MFN 06-215

Docket No. 52-010

**Subject: Response to Portion of NRC Request for Additional Information
Letter No. 33 Related to ESBWR Design Certification Application –
Engineered Safety Features – RAI Numbers 6.2-48 through 6.2-51,
6.2-53 through 6.2-57, and 6.2-64 through 6.2-74**

MFN 06-215

Figure 6.2-53_1: Containment Pressure Response

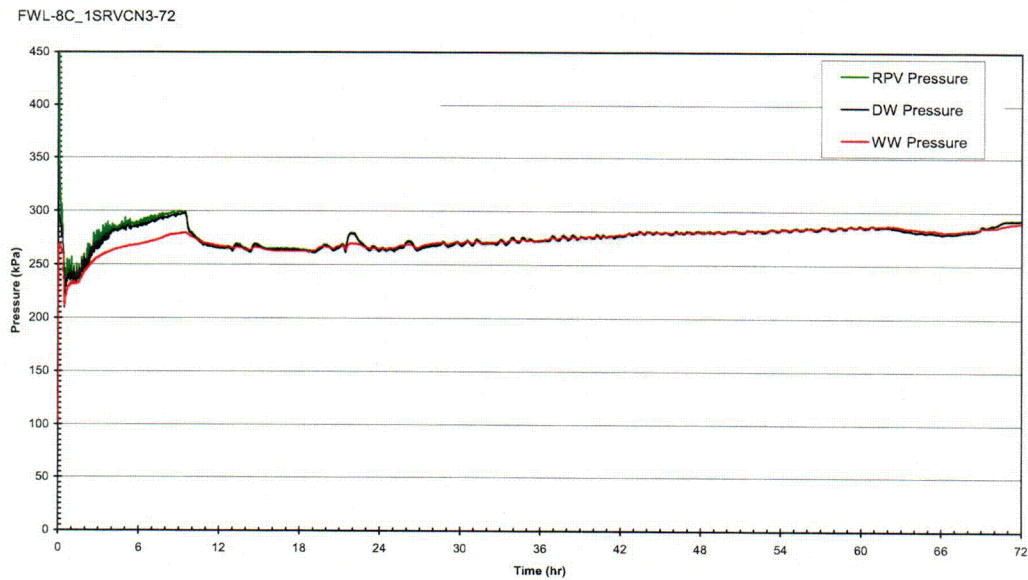
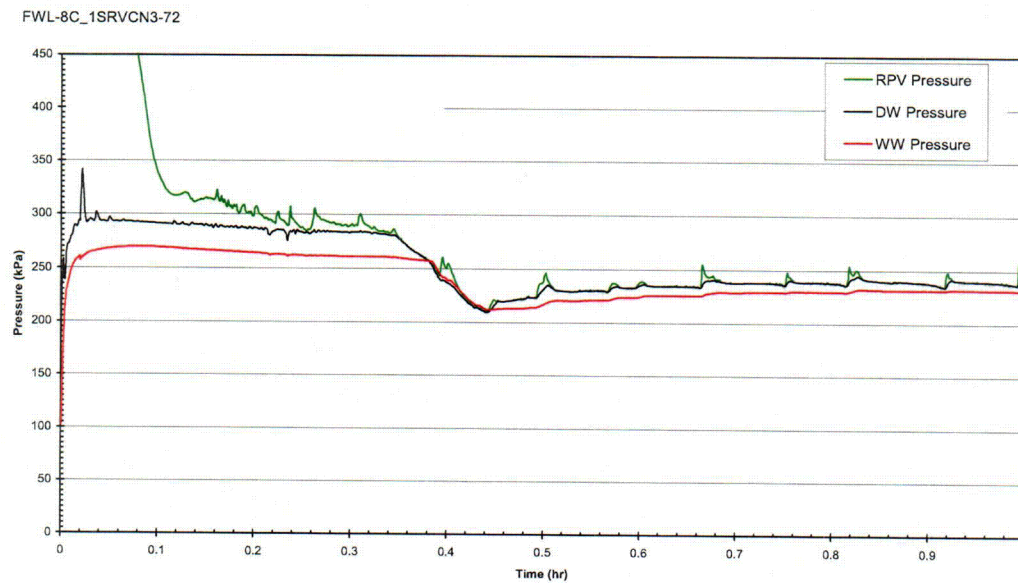
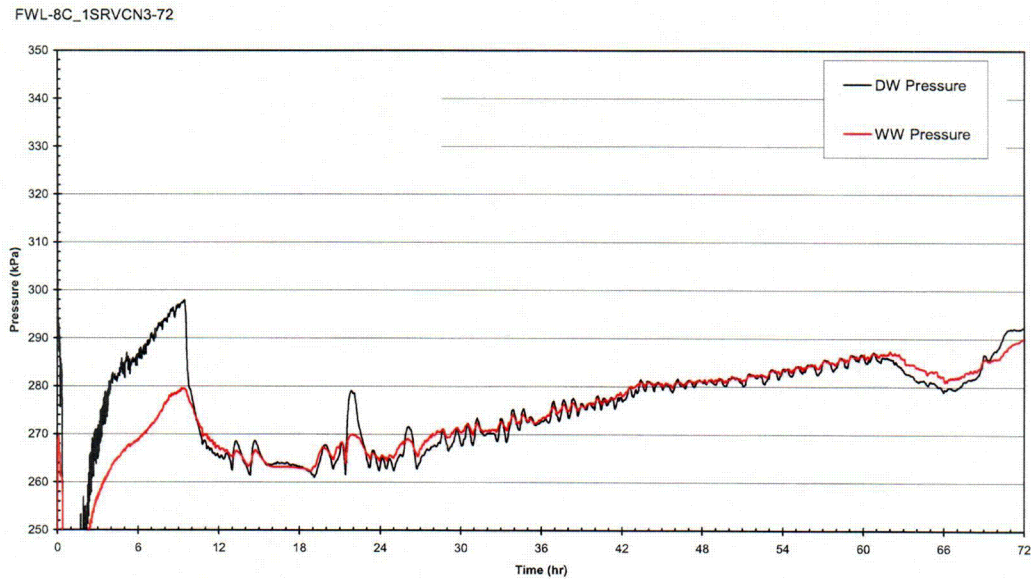
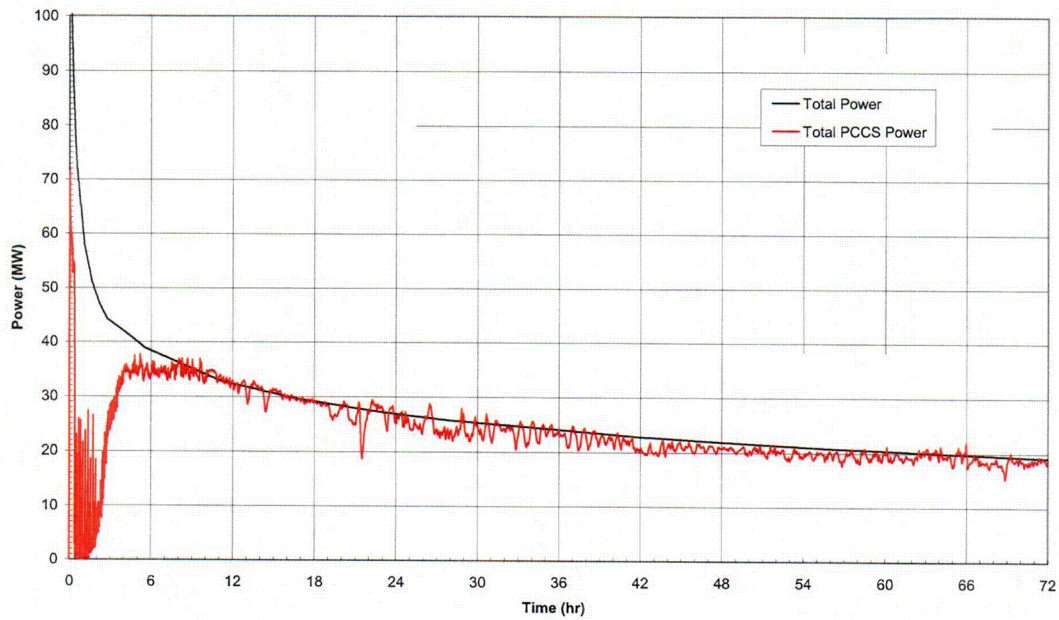
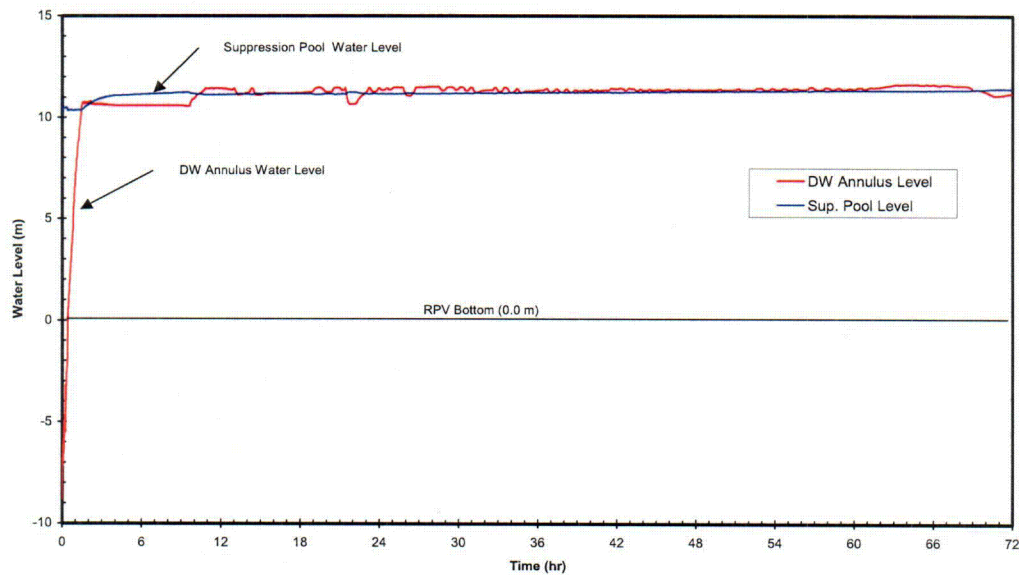
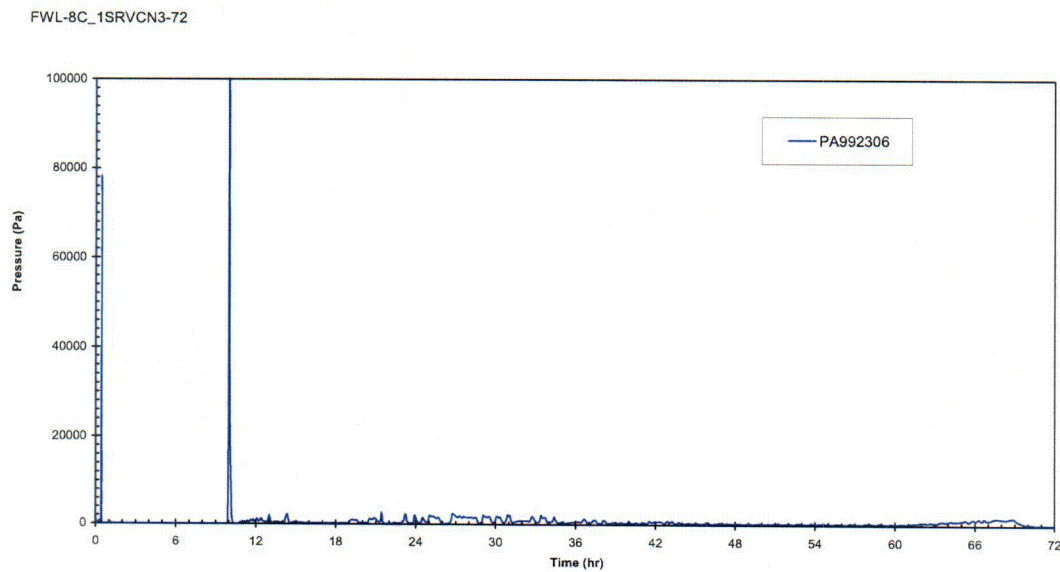
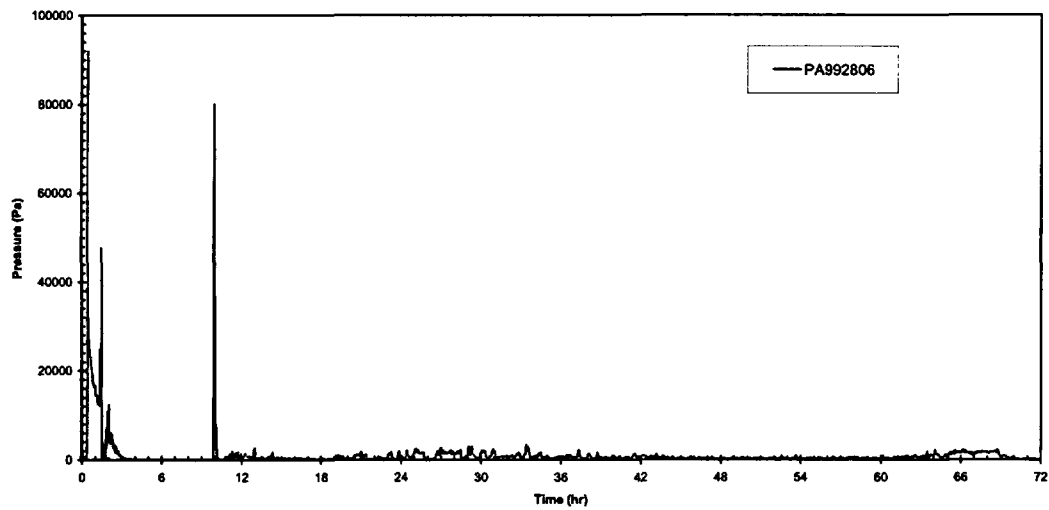
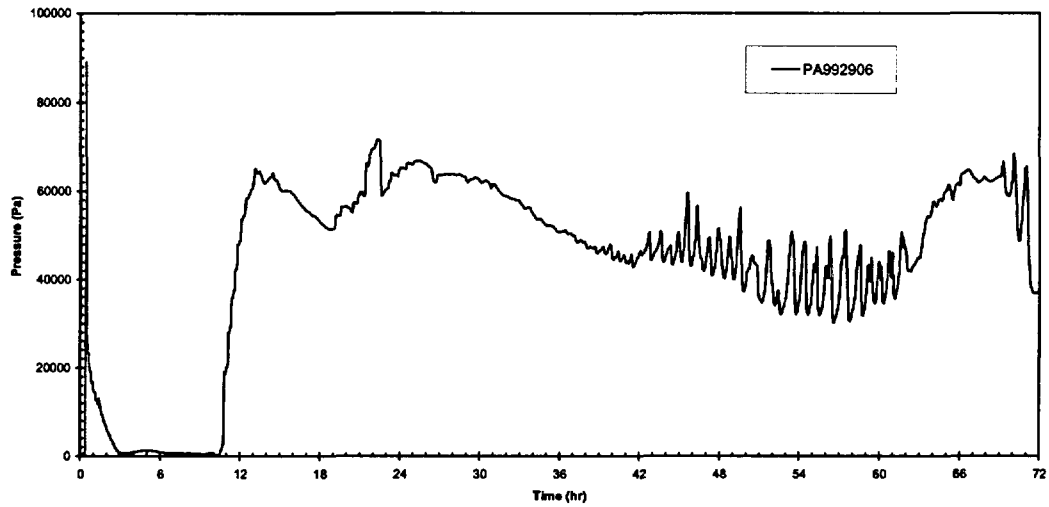
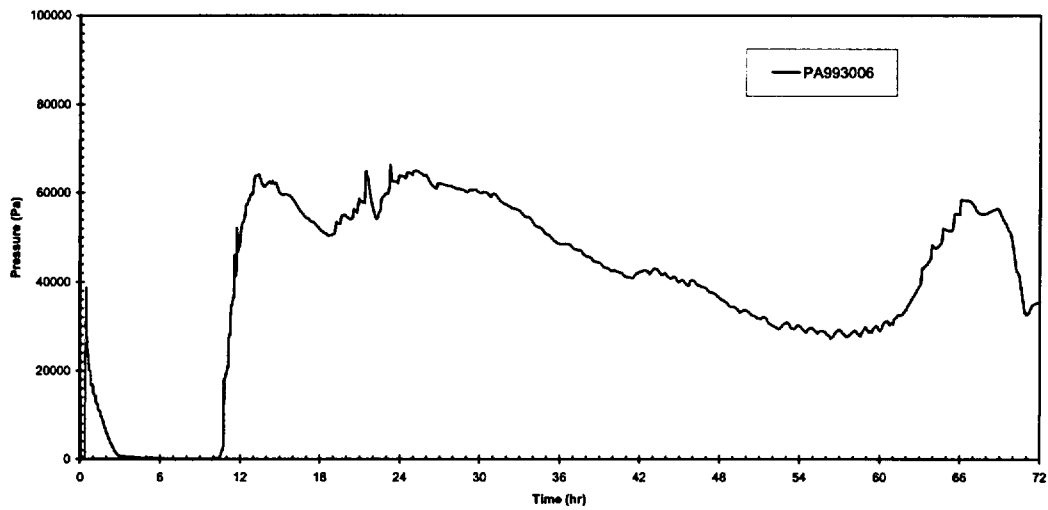
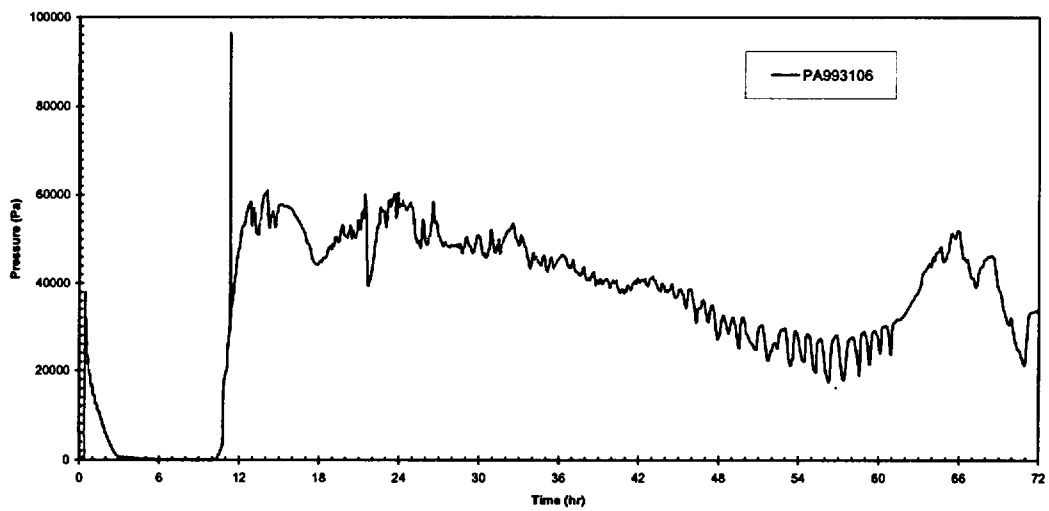
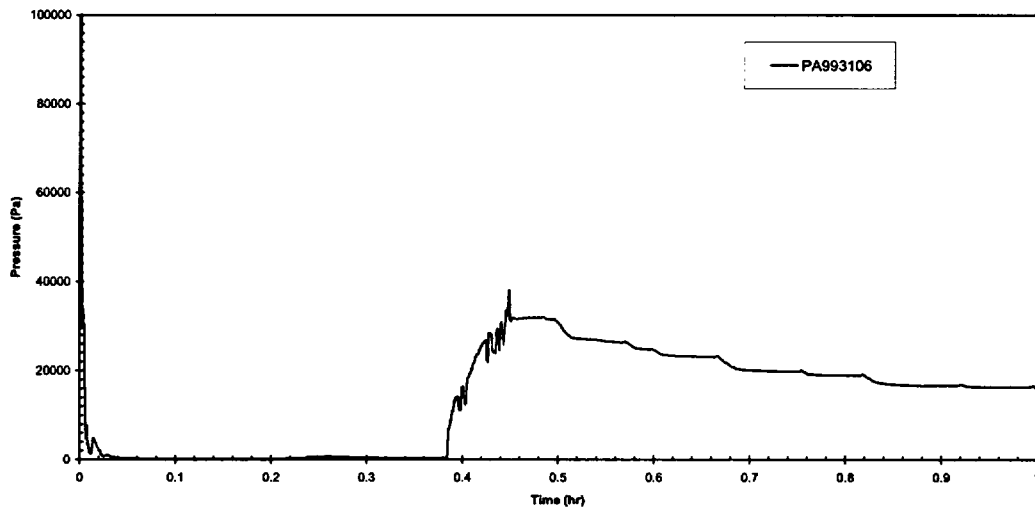
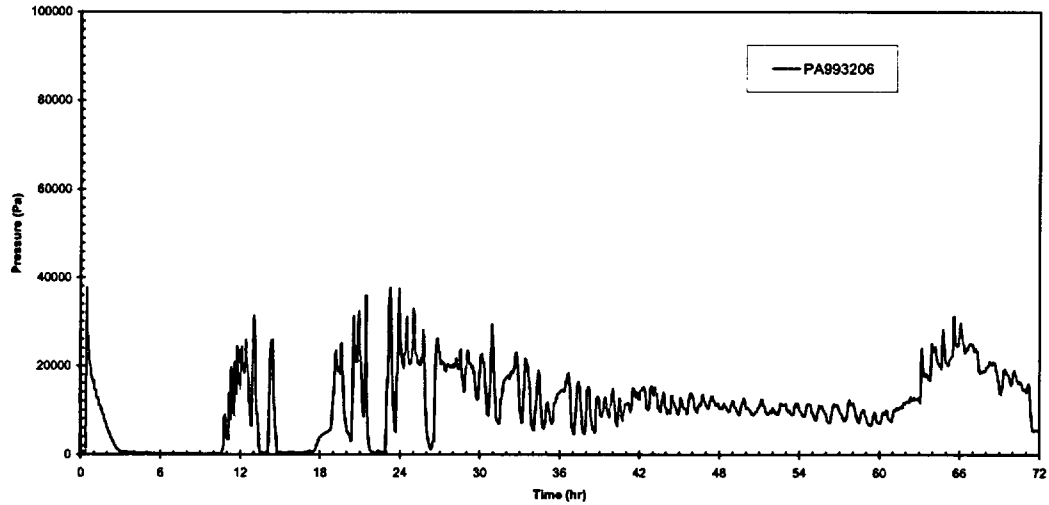
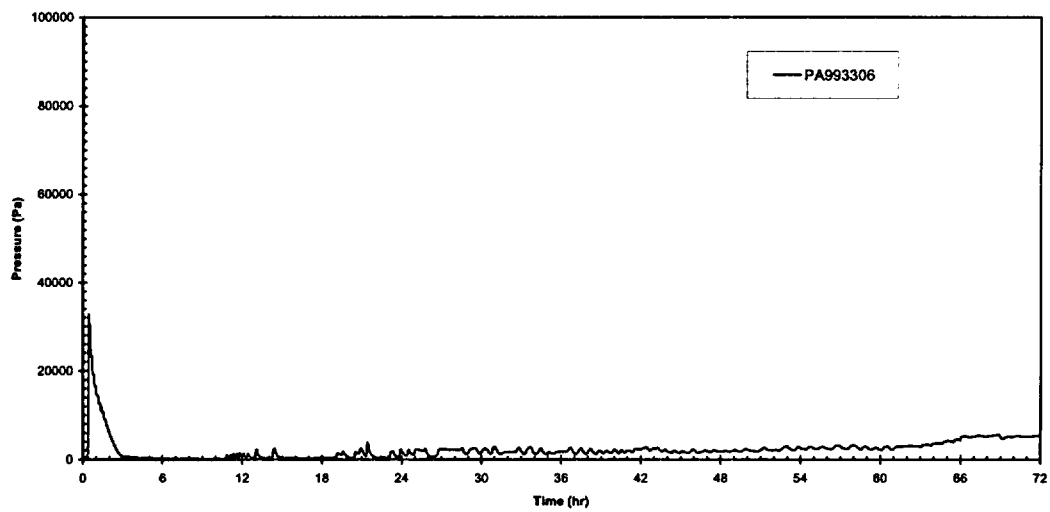
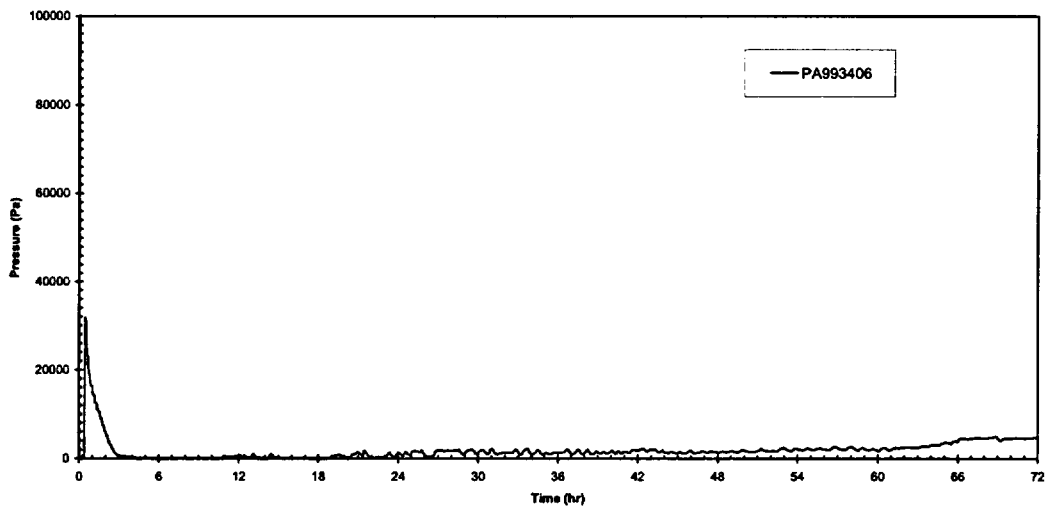
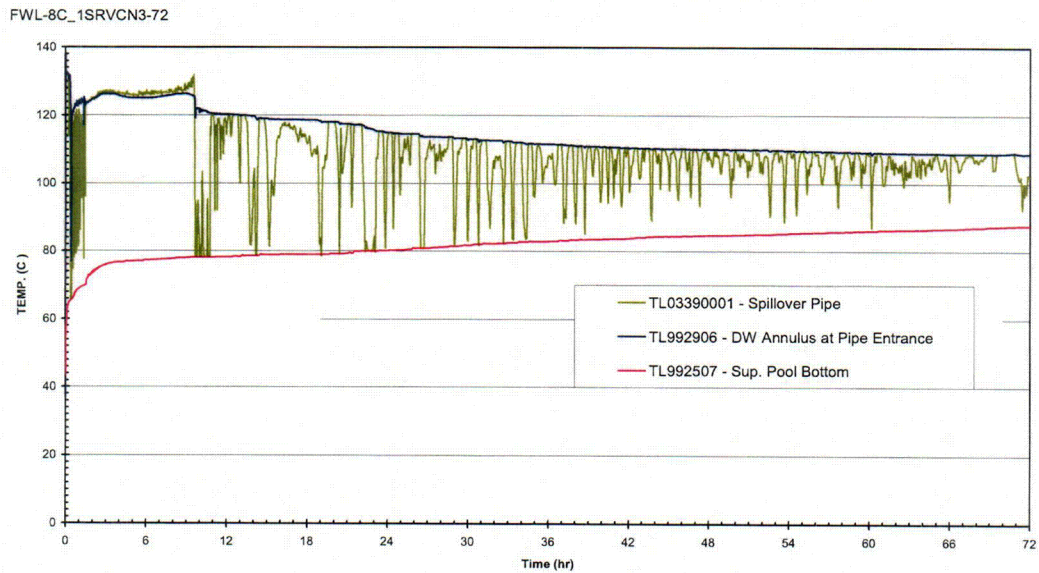
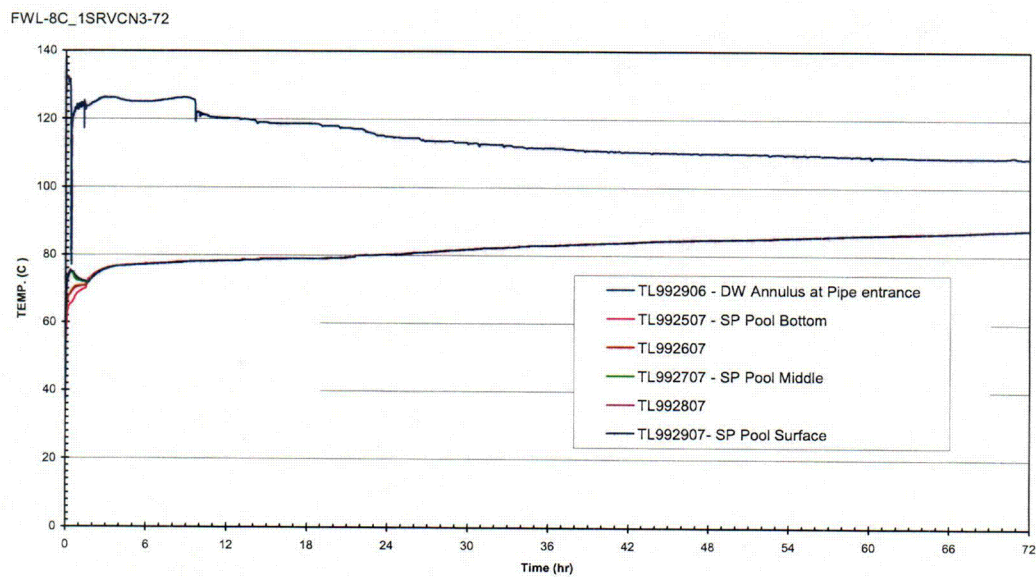
Provide a discussion of the containment response to the feedwater line break (FWLB) using the DCD version of the TRACG model, particularly with respect to the movement of non-condensable gases, mixing and stratification, throughout the containment. Include this information as an update to NEDC-33083P-A, "TRACG Application for ESBWR."

The containment responses to a postulated feedwater line break (FWLB) are discussed in the following paragraphs and figures. The nominal case (DCD Rev. 1, Figures 6.2-9 to 6.2-11) is used in these discussions. These discussions will be included in the Supplement in DCD Section 6.2.

Figure 6.2-53_1 shows the RPV, DW and WW pressures, and Figures 6.2-53_1a and _2 show the DW and WW pressures at different time and pressure scales.

Following the postulated LOCA, the drywell pressure increased rapidly leading to the clearing of the PCC and main vents. The peak drywell pressure for this case was about 341 kPa (49.5 psia) (Figure 6.2-53_1a), and occurred at 78 seconds shortly after the opening of DPVs. This peak pressure is below the design pressure of 60 psia with a large margin. The DW pressure increase is terminated at around 0.05 hrs (Figure 6.2-53_1a), when most of the non-condensable gases in the DW have been purged into the WW (Figure 6.2-53_9a). The DW pressure turns over when the GDSCS initiates at about 300 s. The subcooled GDSCS water continues flowing into the vessel, reduces the steaming from the RPV and the DW pressure. At around 0.38 hrs, the DW pressure drops below the WW pressure, causing the openings of vacuum breakers and allowing some non-condensable gases to flow back into the DW. Consequently, the system pressures drop to a value of about 210 kPa.

Figures 6.2-53_5 through _12 show the non-condensable (NC) gas pressures at different elevations in the DW. Figure 6.2-53_9a shows the NC gas pressure at Level 31 (same elevation level as the vacuum breaker/DW-WW leakage hole) with a short-term time scale (from 0 to 1 hrs). The short-term responses at other levels are similar to that shown in Figure 6.2-53_9a. Most of the NC gases in the DW were purged into the WW within 0.02 hrs. At around 0.38 hrs, some NC gases flow back to DW after the opening of the vacuum breakers.

Subsequently, decay heat overcomes the subcooling of the GDSCS water and steaming resumes (at ~ 0.45 hrs, Figure 6.2-53_1a). The resumption of RPV steaming causes the drywell pressure to increase again from 0.45 to about 9.5 hours. The drywell pressure reaches a second peak of 295 kPa (43 psia) (Figure 6.2-53_1). At about 9.5 hours, the PCCs are able to remove all the decay heat (Figure 6.2-53_3), resulting in a sharp drop in the drywell and RPV pressures.

During the period from 0.45 to 9.5 hrs, the DW pressure is higher than the WW pressure. The PCCS takes steam/NC gas mixture from the DW and purges the NC gases into the WW. Part of the NC gases return to the DW because of vacuum breaker openings, most of it is recycled back into the WW in about 3 hrs (Figures 6.2-53_5 through _12). At 10 hrs, the DW pressure drops below the WW pressure, causing the re-openings of vacuum breakers and allowing some non-condensable gases to flow back into the DW. At this time, the DW annulus is filled with water up to an elevation at 10.65 m (Figure 6.2-53_4). In the TRACG nodalization, cells in the DW from Levels 22 to 28 are filled with water. The NC gas pressure spike shown in Figures 6.2-53_5 and _6 at around 10 hrs is of no significance, because the void fractions in these levels are zero and there are no NC gases in these levels.

During the time period from 10 to 72 hrs, the PCCS continues to take steam/NC gas mixture from the DW and discharges the NC gases into the WW. The steam from the RPV to the DW is flowing through the FW line break and the DPVs, which are located at Levels 33 and 34. The NC gases at Levels 33 through 34 remain at very low concentration due to PCCS action. The NC gases at Levels 29 through 32 are not effectively participating in the PCCS purging process due to lack of steam mixing within these levels.

Figure 6.2-53_3 compares the total heat removal by the PCCs with the decay heat. After the first 9.5 hours, the PCCs are able to remove all the decay heat with some margin to spare. From this point on, all the decay heat generated by the core is transferred to the PCC pools, which are located outside of the containment.

Figure 6.2-53_4 compares the water levels in the drywell annulus and suppression pool. The drywell annulus water level rises due to the break flow discharges from the RPV and from the broken feedwater piping (from the feedwater heaters). In about 2 hours, the drywell annulus water level reaches the elevation of 10.65 m, where the spillover pipes are connected to the drywell annulus. The hot water in the drywell annulus starts flowing into the bottom of the suppression pool via the spillover pipes, causing the suppression pool level to increase and the pool water to heat up. After 9.5 hours, the levels in the drywell annulus and the suppression pool reach an equilibrium position at about 11.2 m.

During the process of filling water in the DW annulus for the first 2 hrs, the NC gases located in the lower DW region are effectively pushed upward to the upper DW and mixed with steam from the RPV.

From 3 to 9.5 hrs, the DW annulus level is lower than the suppression pool level (Figure 6.2-53_4), corresponding to the pressure difference between the DW and WW (Figure 6.2-53_1).

Figure 6.2-53_13 compares the liquid temperatures at DW annulus, spillover pipe entrance and suppression pool bottom. From 2 to 9.5 hrs, the hot water in the drywell annulus flows into the bottom of the suppression pool via the spillover pipes, causing the suppression pool level to increase and the pool water to heat up. After 9.5 hrs, the

spillover flow is intermittent in nature through the rest of the 72 hrs transient. The forced suppression pool stratification model is not turned on for the FWLB because there is significant mass flow to the bottom of the suppression pool. This allows the piped DW annulus hot water to mix with the suppression pool water at upper levels, and includes the effects of the piped DW hot water on the suppression pool surface temperature and on the partial steam pressure in wetwell.

After 9.5 hours, the pressure difference between the DW and WW is oscillatory in nature (Figures 6.2-53_2), causing the flow in the spillover pipe to oscillate in flow direction. The DW hot water, via the spillover pipes, continues to heat up the suppression pool water near the bottom. At 72 hours, the suppression pool bottom temperature reaches the maximum value of 88 °C.

Figure 6.2-53_14 compares the liquid temperatures of the DW annulus, and at various suppression pool elevations. Initially, the pool water heats up due to the main vent and SRV discharge. After the main vents close, the upper levels are impacted by the PCC vent discharge for the first 9.5 hours where the decay heat exceeds the PCC heat removal capacity. For the first 2 hrs, Figure 6.2-53_14 shows the pool temperature stratification due to various heating processes. After 2 hrs, the DW hot water via the spillover pipes flows into the suppression pool bottom, and heats up the suppression pool water through the mixing process. At 72 hours, the suppression pool temperatures at the surface and bottom reach the maximum value of 88 °C.
